Revision Instructions
Callaway Plant Cycle 5
Core Operating Limits Report

FIGURE 5

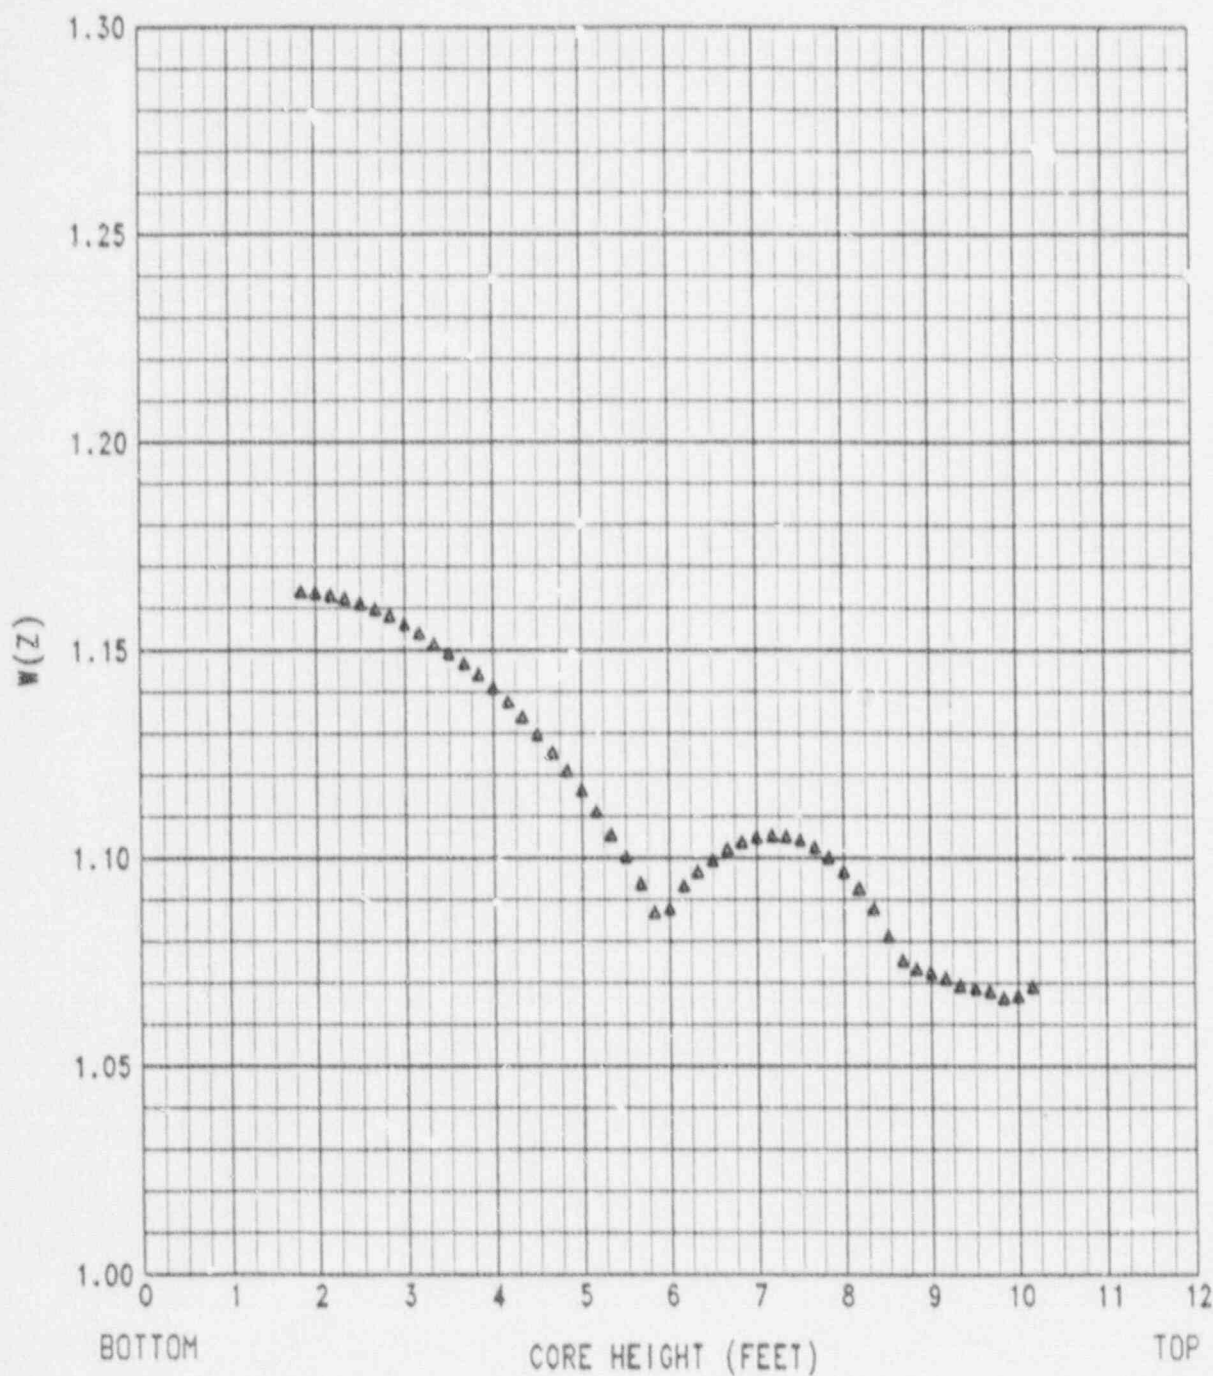
page 11 (Figure 5)
page 12 (Figure 6)

page 11, Rev. 1 (Figure 5)
page 12, Rev. 1 (Figure 6)
